CITY OF SAN MARCOS

CONSTRUCTION CHANGE ORDER

PROJECT: Police Department Additions & Renovations
CONTRACT NO.: 220-149
CONTRACTOR: Trimbuilt Construction Inc
ADDRESS: 12800 North Lamar Blvd.
CITY/STATE/ZIP: Austin, TX 78753

Description: Dispatch-Steel & Shoring Add

NEW BEAM RFI #094 (CO#6)

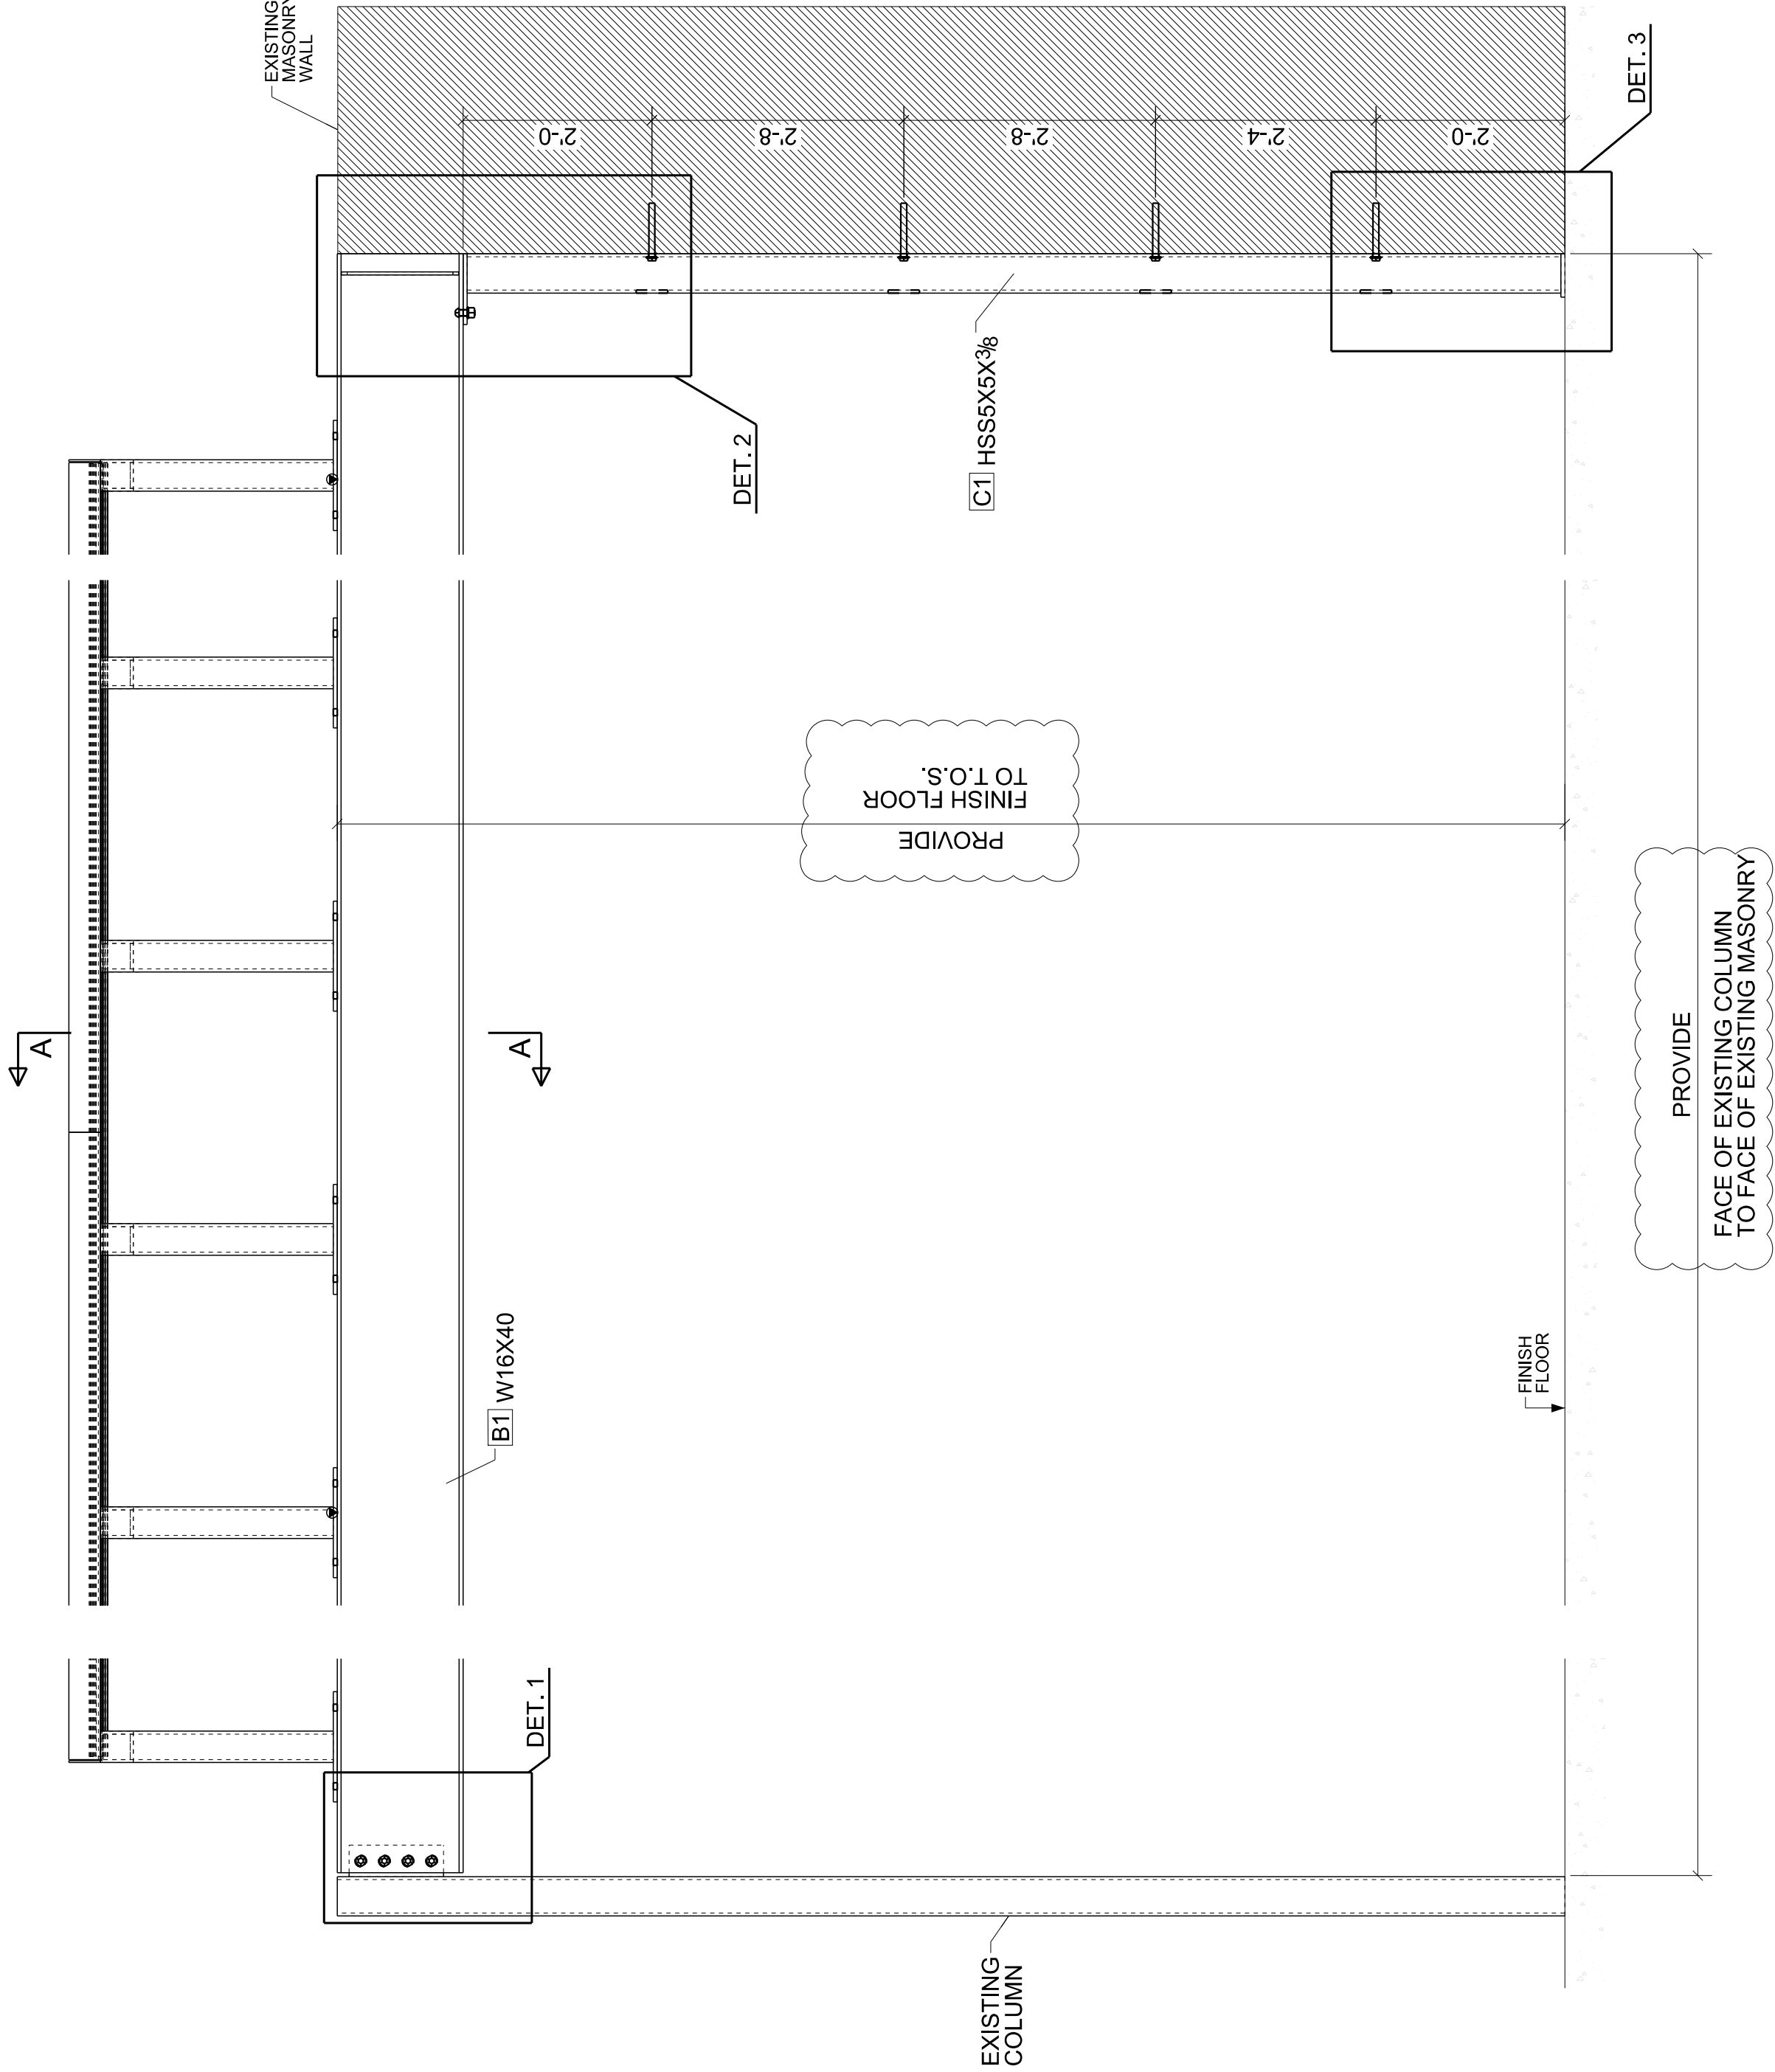
CO #C20 - RFI #94 Dispatch Added Structural Steel & Shoring due to the existing roof is baring on a block wall shown to be demoed which would leave the roof to collapse.

The demo and scheduled construction in the Dispatch area has been stopped from the discovery of this condition on 6/11/21. The fabrication date or install of new structural members will not be known until the attached Dennis Steel shop drawings and the cost of this change order are approved. This is a critical time sensitive situation due to the stoppage of work in this area.

1. SEE RFI #094
2. SHORING & DEMO IS NOT INCLUDED
3. INSTALLATION OF NEW COLUMN & BEAM ONLY

SK6

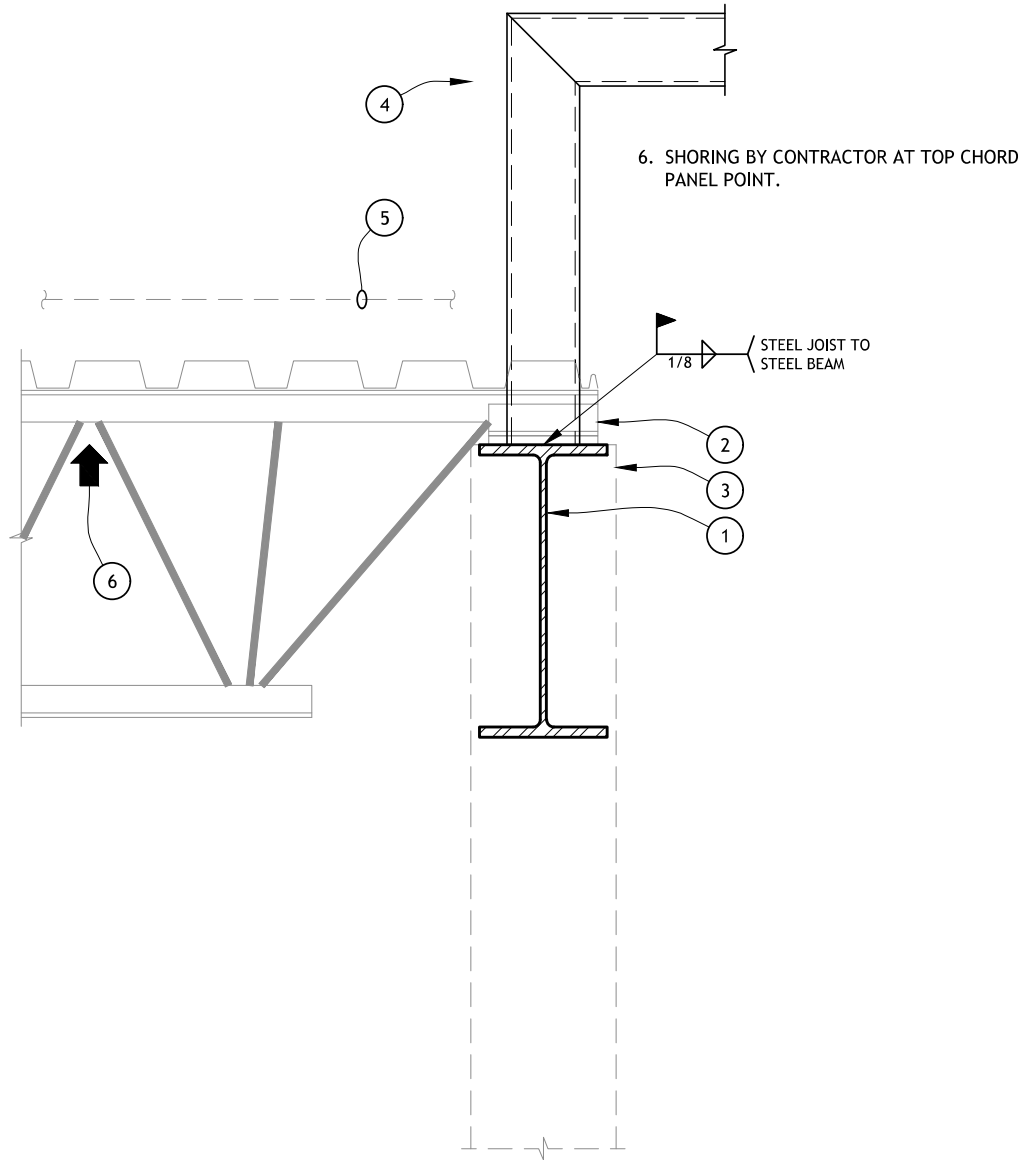
Roof trusses are baring on the existing Brick / Block walls (See attached document with screen shots).

The attached document with pictures shows a beam and column stopping at the CMU/Brick wall. The court yard CMU/Brick wall that is separating Dispatch from the Court Yard is baring for the existing roof trusses over Dispatch.

The attached document with pictures shows a flange where the existing roof system is directly baring on the CMU /Brick wall.

At this time Trimbuilt can not remove the existing wall as show on the drawings due to the roof would not have support. Also on hold is the structural steel for the Court Yard roof.

Provide structural direction.

See sketches SK6, SK7, and SK8 for supporting the existing roof prior to removing the existing masonry wall.

1. NEW STEEL BEAM - W16x40.
2. EXISTING STEEL JOIST.
3. LINE OF MASONRY WALL TO BE REMOVED.
4. FOR INFORMATION NOT SHOWN, SEE
DETAIL 6/55.02.
5. LINE OF EXISTING ROOFING - REMOVE AND
REPLACE AS REQUIRED.

RFI #94 Courtyard 003 -D-20 Existing Exterior Brick/Block Removal.

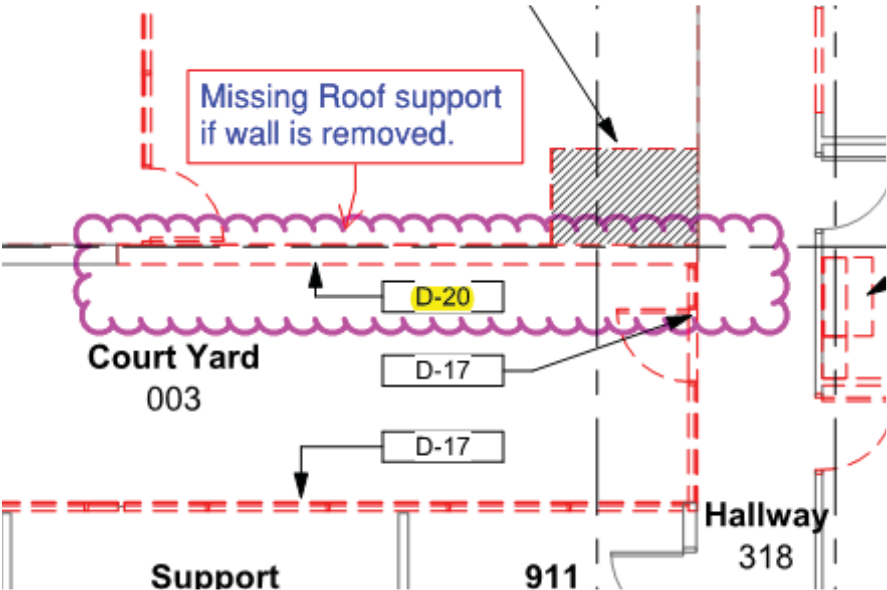
Roof trusses are baring on the existing Brick / Block walls.

The picture below shows a beam and column stopping at the CMU /Brick wall.

The courtyard CMU/Brick wall that is separating Dispatch from the courtyard is baring for the existing roof trusses over Dispatch.

The picture below shows a flange where the existing roof system is directly bearing on the CMU /Brick wall.

At this time Trimbuilt cannot remove the existing wall as show on the drawings due to the roof would not have support. Also on hold is the structural steel for the courtyard roof.

Provide structural direction.
